IAEA Review of Safety Related Aspects of Handling ALPS-Treated Water at TEPCO's Fukushima Daiichi Nuclear Power Station

**Report 1: Review Mission to TEPCO and METI
(February 2022)**

Report 1: Review Mission to TEPCO and METI (February 2022)

FIG. 4.3. Dose commitment over time due to build-up and accumulation of radionuclides in the environment.

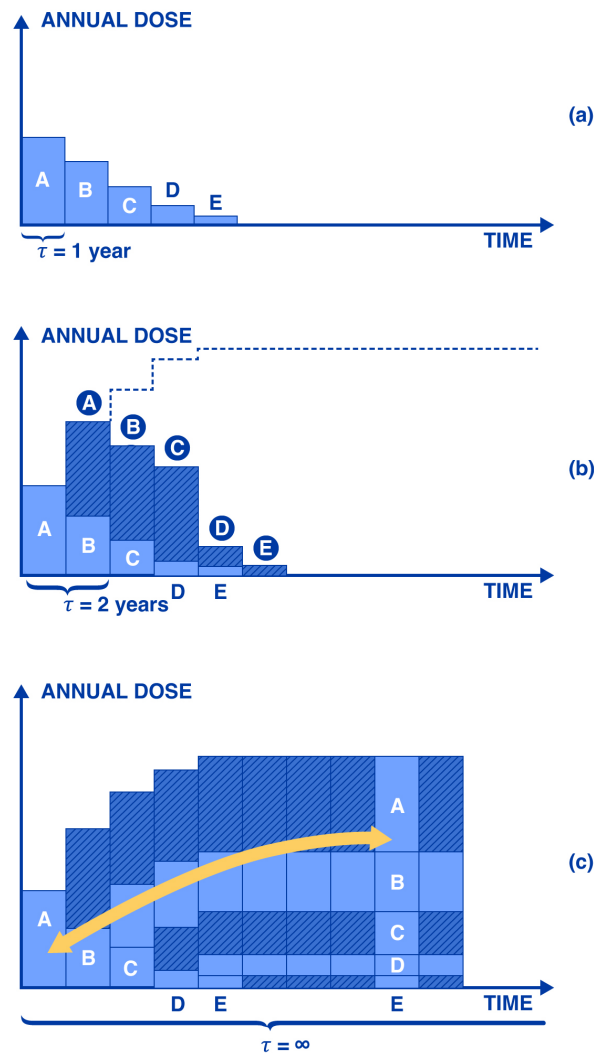
The Task Force noted that in order to take into account build-up and accumulation of radionuclides in the environment during the operation of the facility, the concept of ‘dose commitment’ can be used. Namely, the total dose that would eventually result from the discharges of radioactive substances. Figure 4.3 represents the ‘dose commitment’ as follows: (a) from first the year of release $A + B + C + D + E$, (b) from the second year of release (shaded area) $A + B + C + D + E$, and (c) under conditions of constant discharge (the time T could initially taken to be infinite and then adjusted to the maximum time of release).

In the REIA presented by TEPCO, committed effective doses are currently calculated from 1 year's discharge. The Task Force noted that these calculations need to take account of the proposed discharge period of 30 years and the fact that, during this 30 year period, some radionuclides may accumulate in the environment (e.g. in the sediments). The Task Force added that the committed effective dose to the representative person in the final year of the discharge, taking into account build-up and accumulation of radionuclides in the environment, needs to be calculated in the REIA. If this approach is followed, the committed dose to the representative person in the planned final year of discharge will take account of the bioaccumulation in the environment over the total discharge period and beyond the period of discharge.

TEPCO explained that they plan to document the assumptions made in the calculation of doses very clearly in the revised REIA and to provide evidence of the conservative nature of their assumptions. This will include the assumptions made on accumulation of radionuclides in the sediment and the identification of the exposure situations for which accumulation of radionuclides in the environment is accounted for in the REIA. TEPCO also agreed to look at the impact on their model predictions of bioaccumulation of radionuclides in the ocean sediments over the period of the discharge and whether this needed to be included in the revised REIA.

FIG. 4.4. Status of the areas around FDNPS.

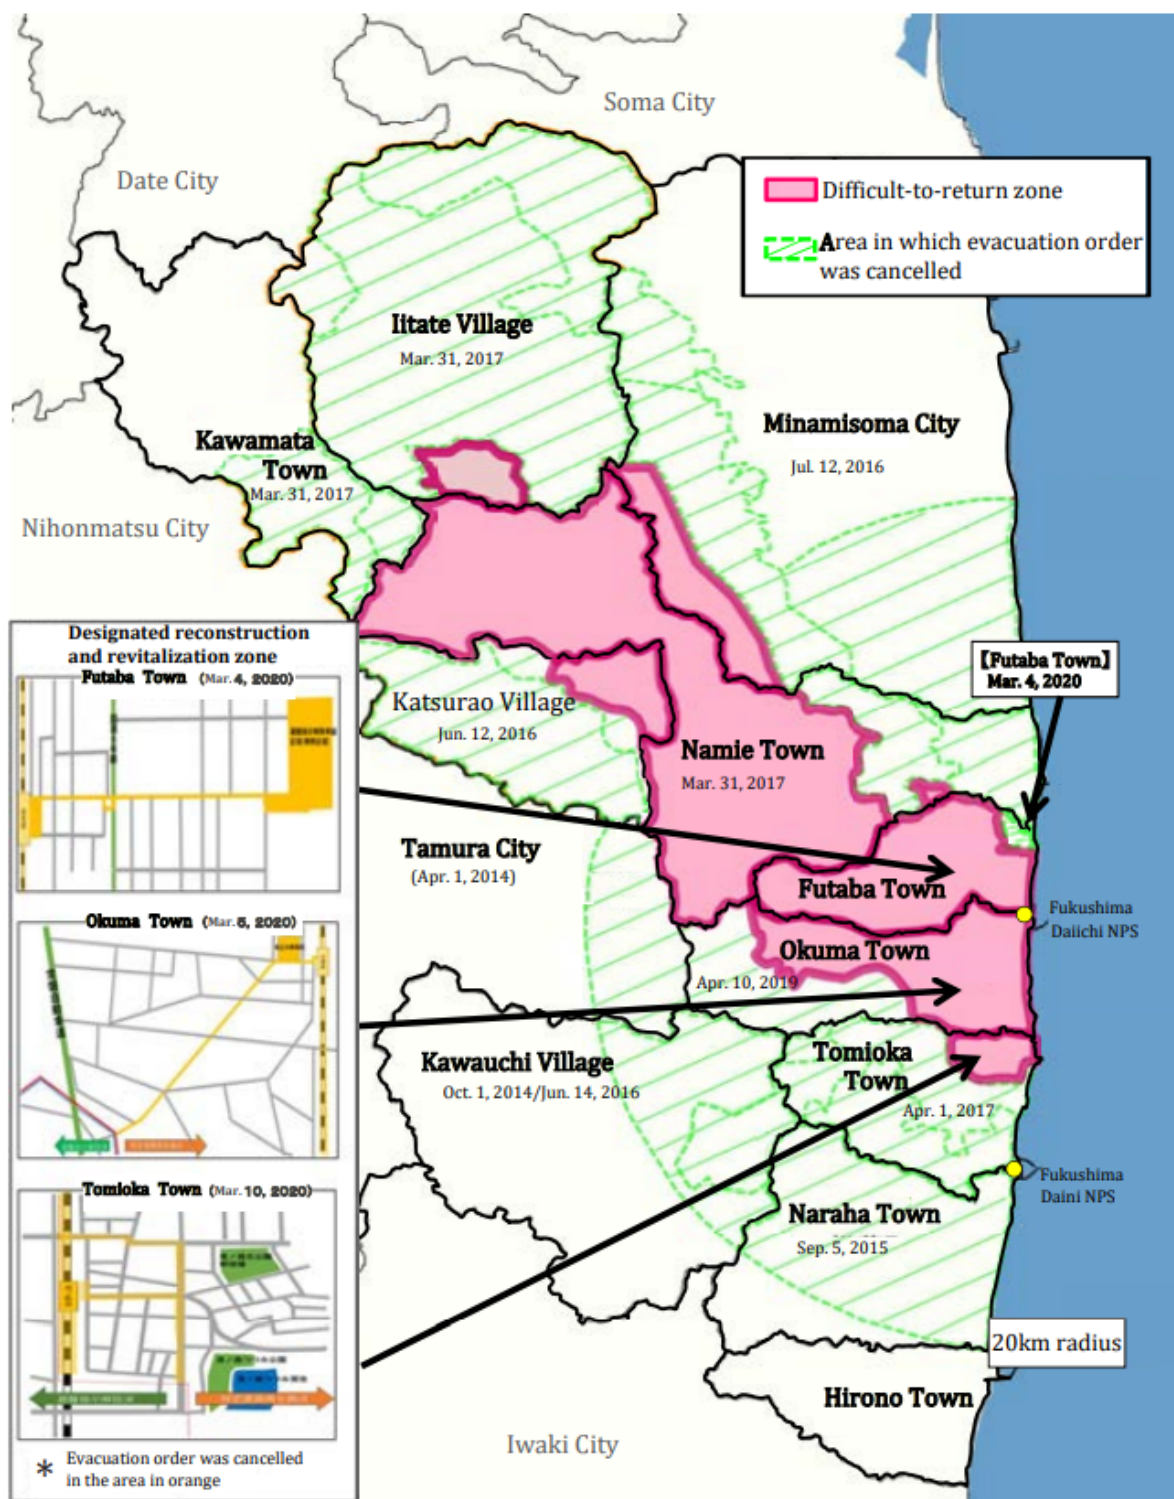
For the purposes of calculating doses to the representative person, TEPCO used the marine dispersion model to calculate activity concentration in sea water in a 10 km x 10 km area around the discharge point and these activity concentrations were then used to estimate doses from all the exposure pathways considered. TEPCO explained that this was a conservative assumption as members of the public cannot live or undertake activities close to the coastline within the ‘difficult to return zone’ or the ‘no claim for fishing zone’ (see Fig. 4.4). The Task Force questioned whether the average concentration used is conservative given the higher concentrations in the sea predicted along the coast due to the sea currents both within the ‘difficult to return zone’ and just outside it.

The assumption of where the representative person is assumed to be located relative to the discharge point was also discussed within the context of the assumption of using the average concentration in seawater rather than potentially higher predicted concentrations of radionuclides along the coastline, both within the ‘difficult to return zone’ and the fishing ports just outside it to the north and south. The Task Force suggested that TEPCO further consider the possible locations of the representative person both at the current time with restrictions in place and also for the future, if people return to the area and have access over the proposed 30 years of discharge, including use of beaches and areas for local fishing.

TEPCO agreed to explain their rationale for taking the average concentration in sea water in a 10 km x 10 km sea area and why it is appropriate (and conservative) for all exposure pathways. TEPCO will describe in more detail the habits of people living in the area to explain that it is consistent with regional data available. TEPCO will also consider in more detail possible locations for the representative person along the coastline in the revised REIA, even if the probability of people returning to the area is low.

Fig. 5.1: Steps in setting discharge limits, indicating those responsible (fig. 3 of GSG-9 [4]).

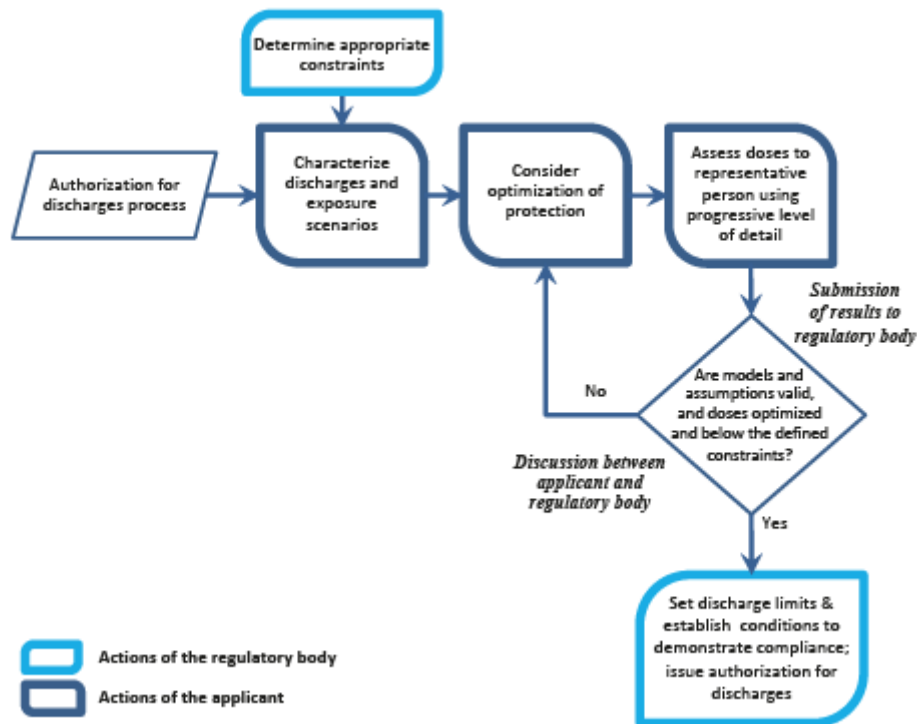
The Task Force noted that to be in line with the IAEA international safety standards, the dose constraint needs to be used as an input to the REIA to calculate the maximum discharge rate and to inform the NRA’s decision about the establishment of the discharge limits.

After discussions between the Task Force and METI/TEPCO, the Task Force suggested that the value of 0.05 mSv per year – which is the operational target for nuclear power stations in Japan – could be used in the place of a dose constraint for the discharge of the ALPS treated water. The Task Force advised TEPCO to revise the REIA using this dose (0.05 mSv per year) as an input to the REIA to demonstrate whether the discharge limit for tritium is appropriate and to inform discharge limits for other radionuclides where appropriate.
